AGENDA

President and Board of Trustees
Village of Arlington Heights

March 19, 2018

- A. Sigwalt Apartments/CA Ventures - 45 S. Chestnut Ave. -
PC#17-016
PUD, Preliminary& Final Plat of Subdivision, Rezoning, Variations

C3.0

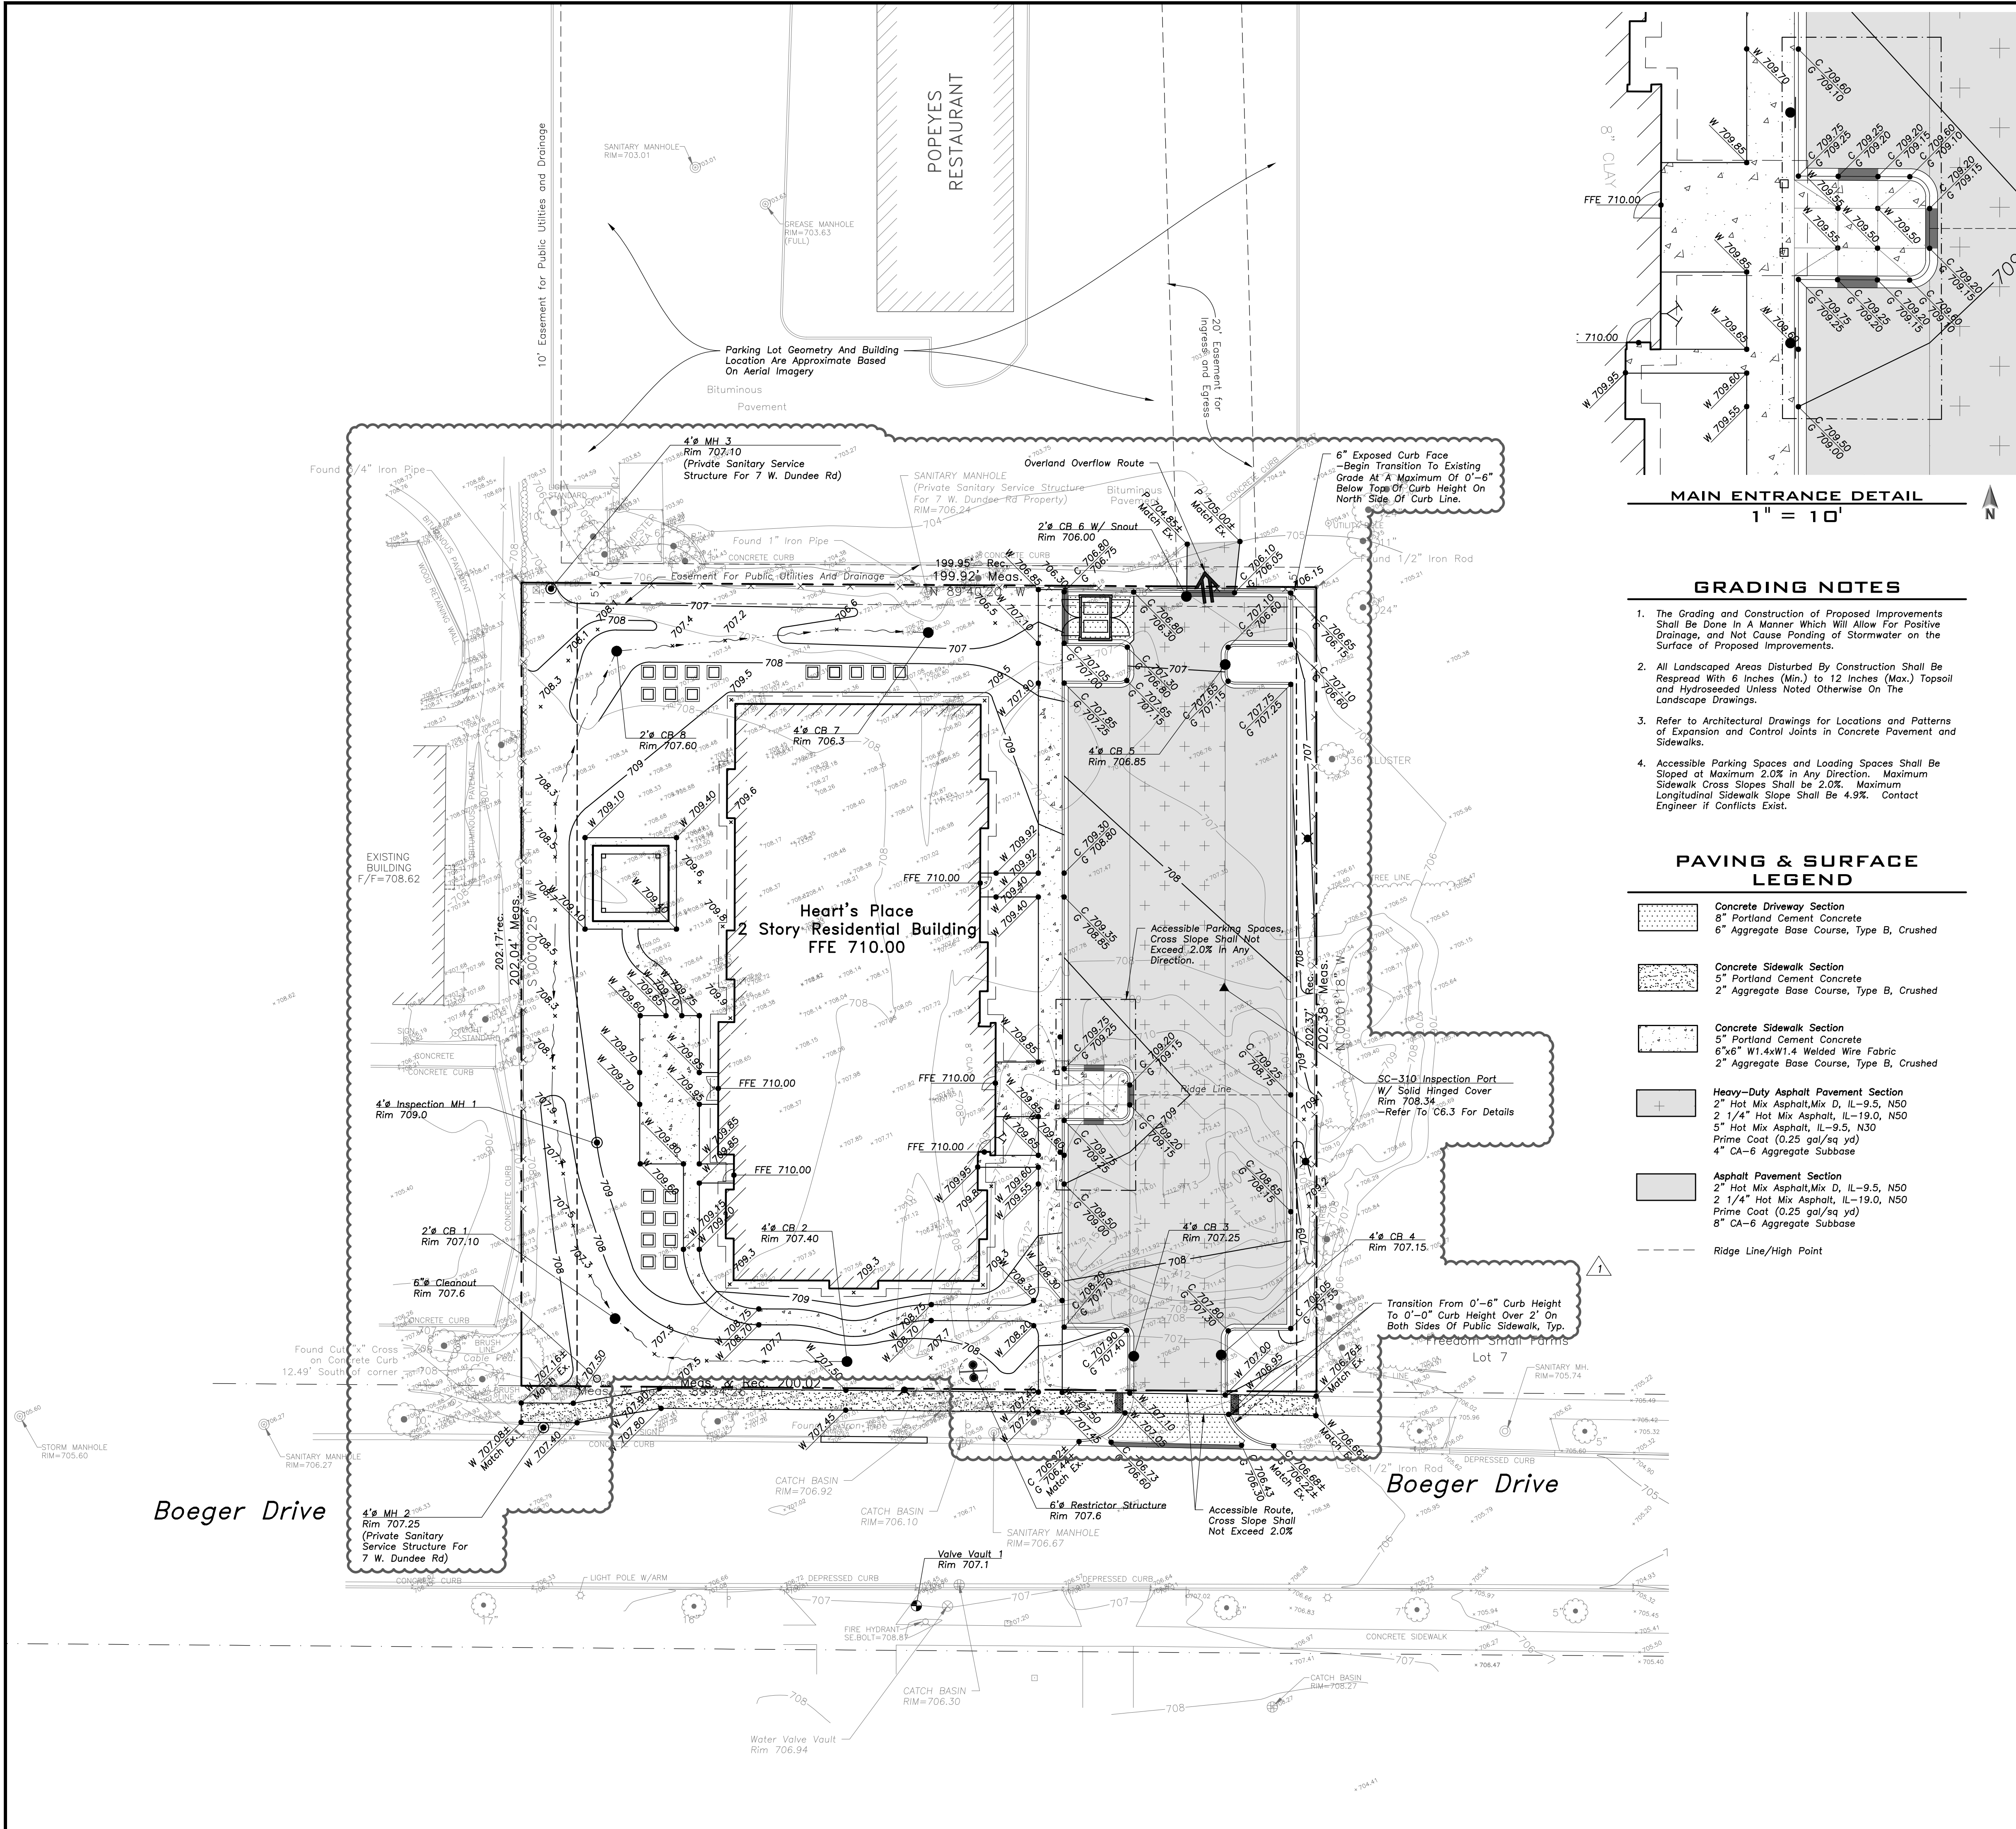
13. Sheet C-3.0: Label the existing pipe inverts to be plugged per MWRD requirements for the two existing sanitary manholes where the existing sanitary sewer main is being removed through the center of the property.

14. Sheet C-3.0: The proposed water service pressure connection shall be contained in a 5' minimum diameter valve vault. Show the valve vault on the plans.

15. Sheet C-3.0: Where will the water meter be located? The service line has an unmetered private hydrant shown.
16. Sheet C-4.0: Show the proposed grading contours along the east side of the parking lot to show how the proposed grading ties into the existing grading on the lot to the east.
